Model: Gim-MF1.5dM	Date: 27-Jul-16	No.: RM0A0003a
--------------------	-----------------	----------------

Subject: Firmware Release Note: Web Uapl		Prepared by: Y. Gaman	
From: 2nd Tech Service Sect., MFP/Printer Tech Service Dept.			
Classification:	<input type="checkbox"/> Troubleshooting <input type="checkbox"/> Mechanical <input type="checkbox"/> Paper path <input type="checkbox"/> Product Safety	<input type="checkbox"/> Part information <input type="checkbox"/> Electrical <input type="checkbox"/> Transmit/receive <input checked="" type="checkbox"/> Other (Firmware)	<input type="checkbox"/> Action required <input type="checkbox"/> Service manual revision <input type="checkbox"/> Retrofit information <input checked="" type="checkbox"/> Tier 2

This RTB has been issued to announce the firmware release information for the **Web Uapl**.

Appendices > SP Mode Tables > Main SP Tables-5 (Controller) > SP5-XXX (Mode)

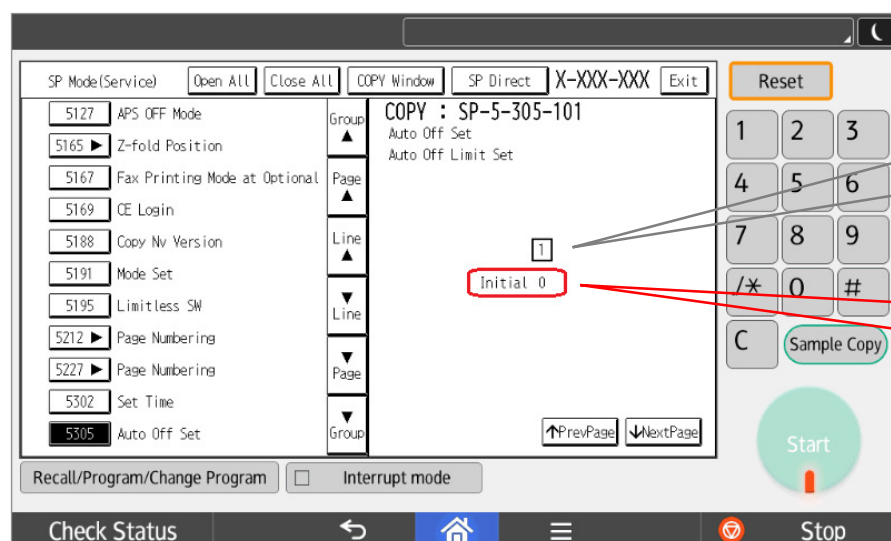
The default value of SP 5-305-101 was corrected from '0' to '1'.

The ***Initial*** value appears as '0' in the SP mode, but the actual value is set to '1' at the factory. (***'0' indicates machines installed in Japan and '1' indicates machines installed outside of Japan.***)

DO NOT change this SP setting. ***Always maintain '1' unless when running tests. If the NVRAM is replaced, set the value back to '1.'***

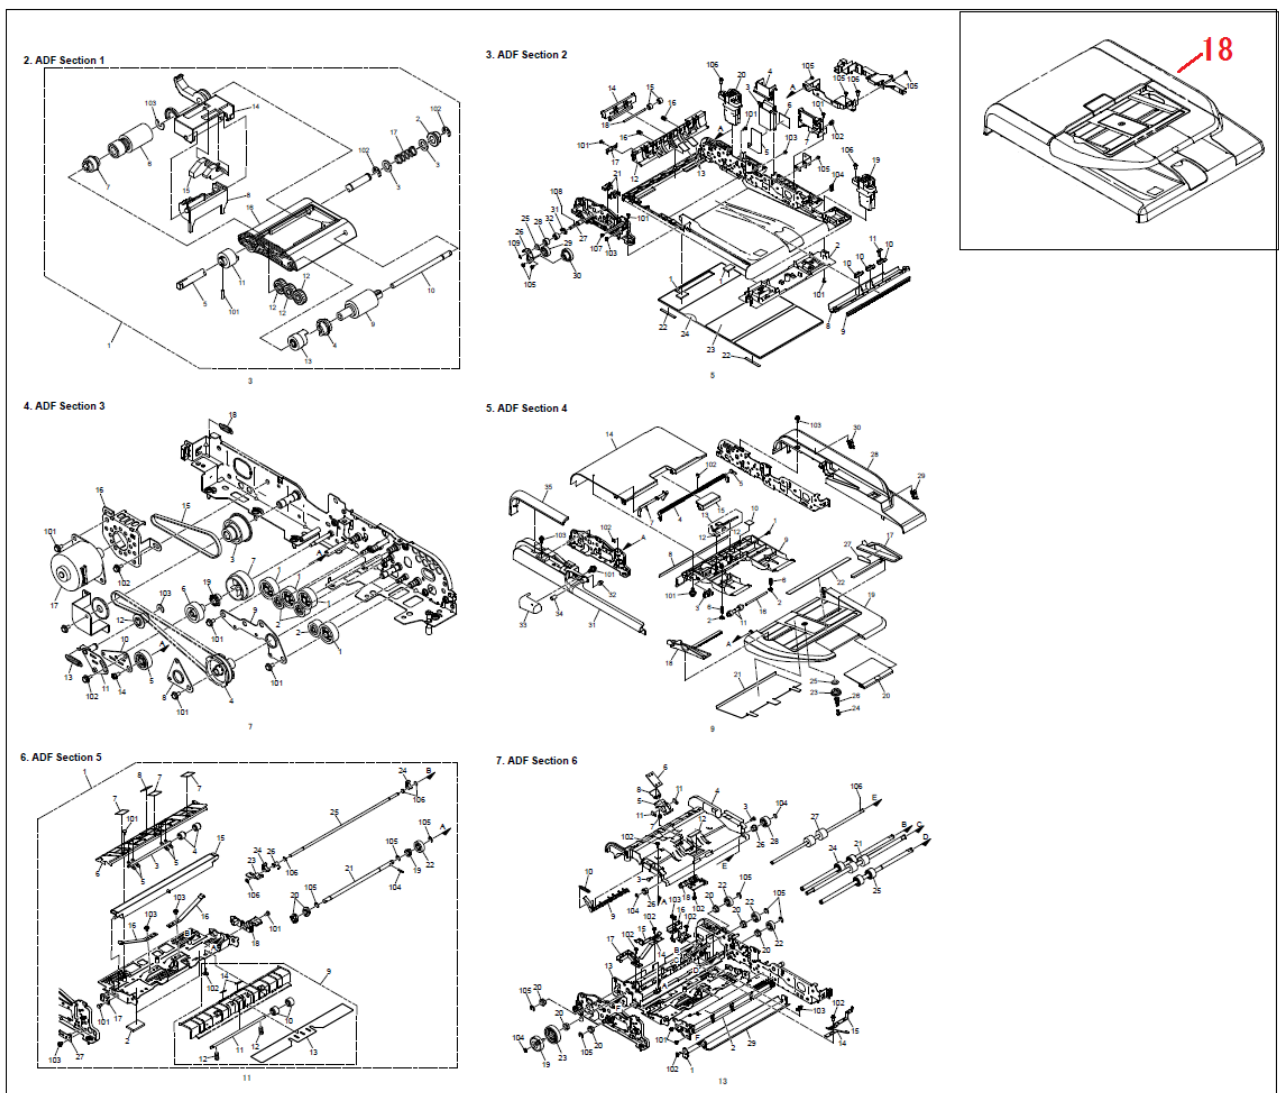
Old part number	New part number	Description	Q'ty	Int	Page	Index	Note
-	D3DJ0014	ADF:ASS'Y	1	-	4	18

Change/Reason: The ADF Ass'y was added as a service part.

22. Electrical Components Section

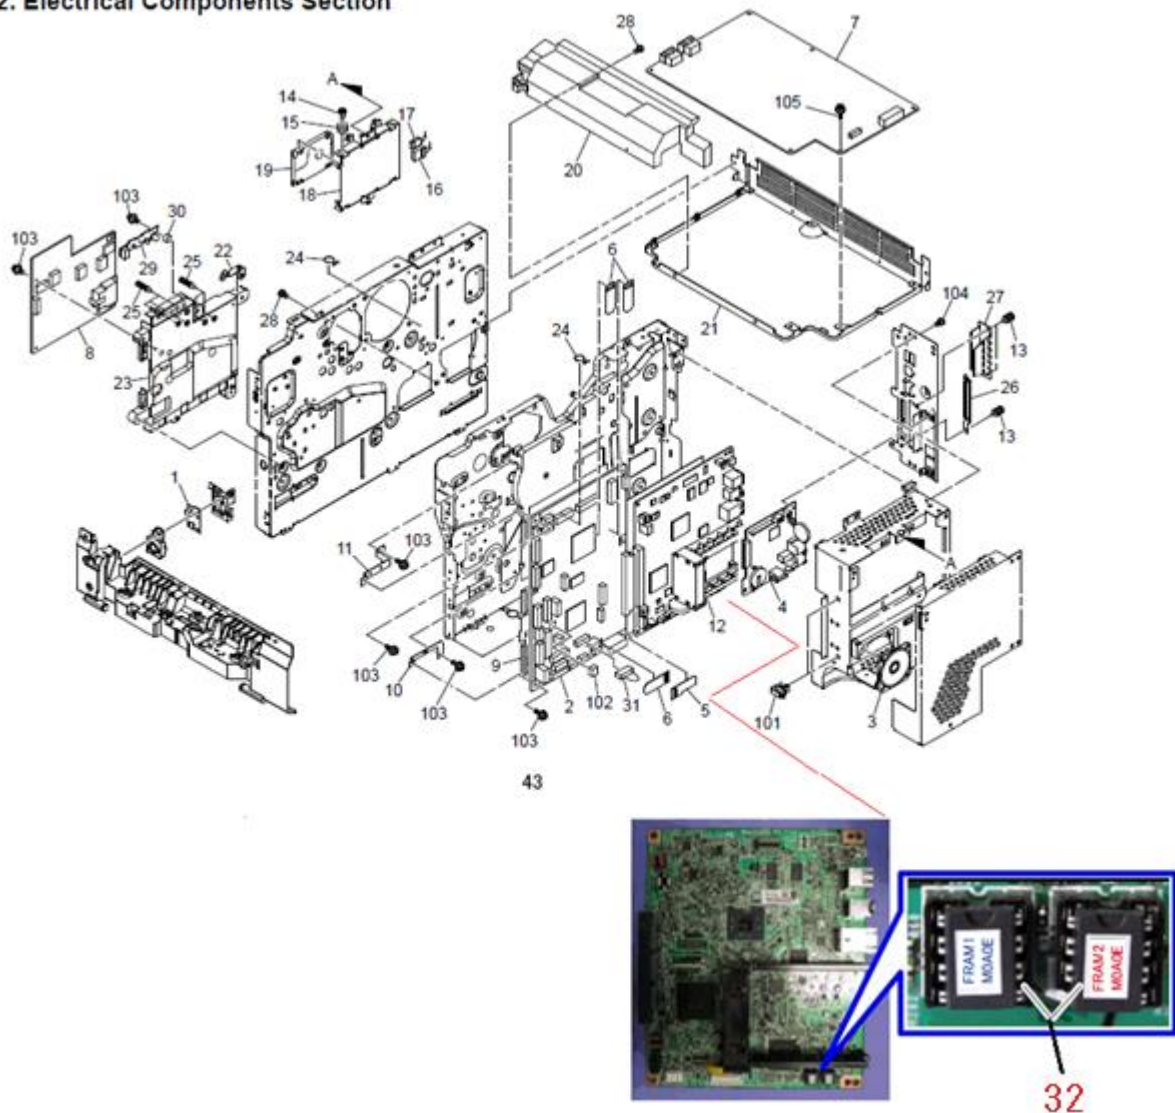
Change/Reason: NVRAM was added as a service part.

Old part number	New part number	Description	Q'ty	Int	Page	Index	Note
-	M0A09590	NVRAM	1	-	44	32

NOTE: The above part contains two types of NVRAMs as a set.

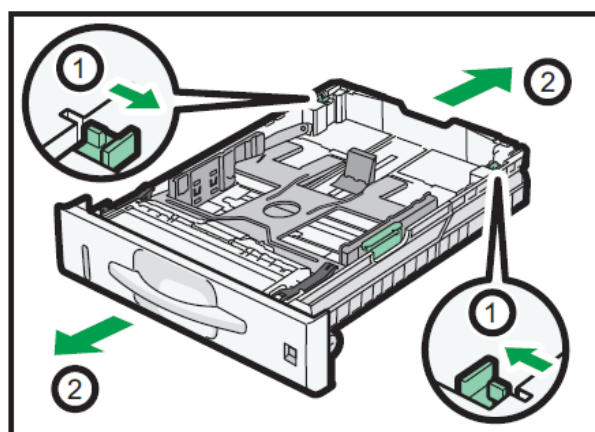
“Paper No Feed” occurs (Jam Code: 3, 4, 5).

- A) The end fence may be kicked a few notches back by the loaded paper if the fence is adjusted after the paper is loaded.
- B) The end fence may be pushed back when the paper is loaded if the catches (1) do not lock the tray extension.

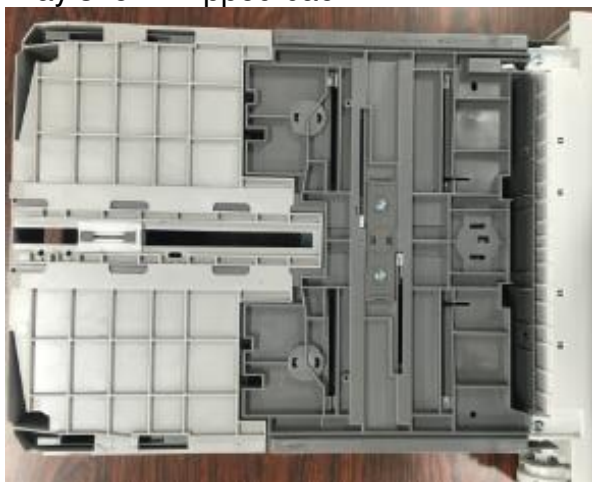
Options for fixing the end fence in place:

Advise the user to fix the position of the end fence **before** loading the paper (as mentioned in the Operator's Instructions). If the user uses only A4 SEF, Letter SEF, or A5 SEF, then the end fence can be fixed in place using the following screw:

P/N	Description	Necessary Q'ty
04583010N	HEXAGON HEAD TAPPING SCREW:3X10	1

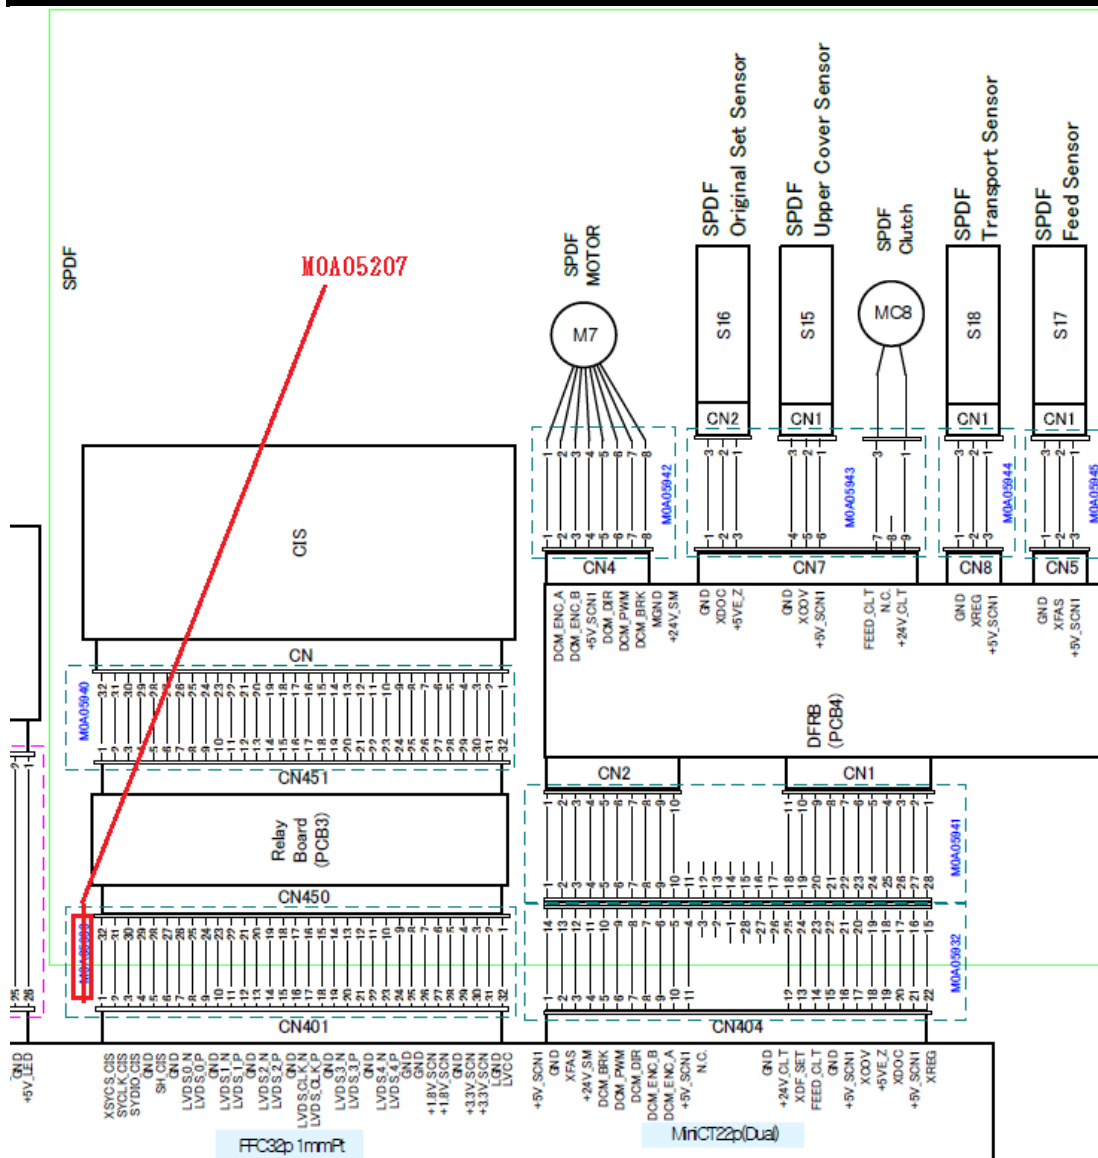
Change/Reason: Please correct your part catalog as shown.

Old part number	New part number	Description	Q'ty	Int	Note
M0A05930	M0A05207	HARNESS:SCANNER:FFC:CIS:ASS'Y	1	-

20. Drive Section 1

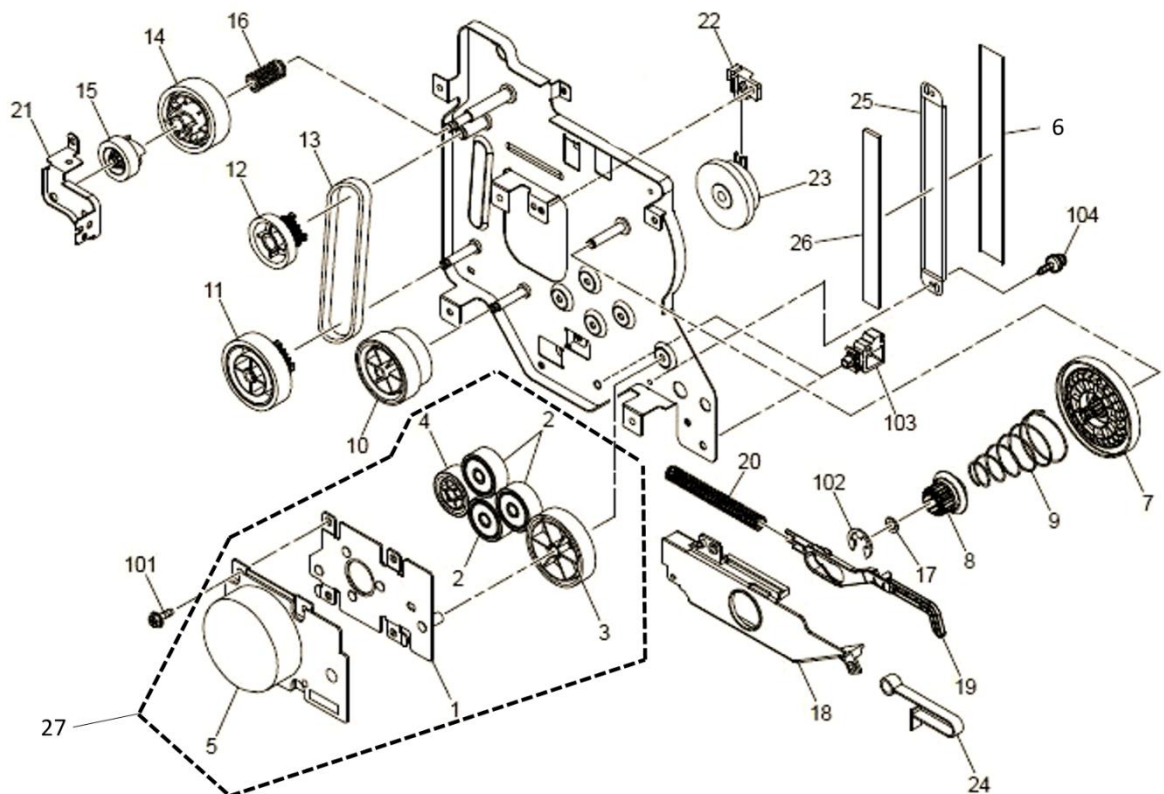
Change: The following part was registered as a service part.

Old part number	New part number	Description	Q'ty	Page	Index	Note
-	M0A00035	DC BRUSHLESS MOTOR:MF1.5:ASS'Y	1	39	27

P/N M0A00035 is assy including parts from index 1 to 5

3. ADF Section 2

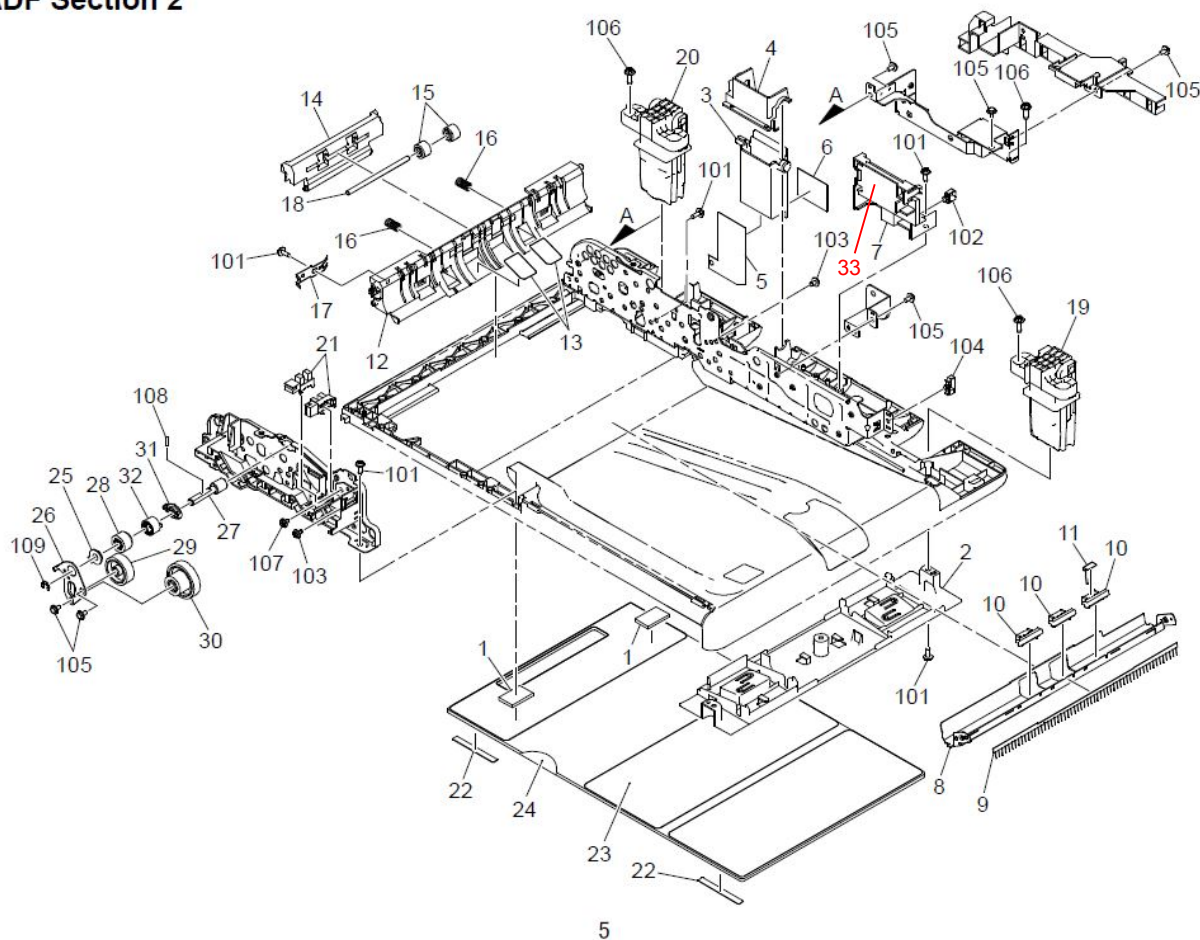
Change/Reason: Parts Catalog correction / An omission of service part)

Part Number	Description	Q'ty	Page	Index	Note
M0A05922	PCB:DFRB3	1	5	33
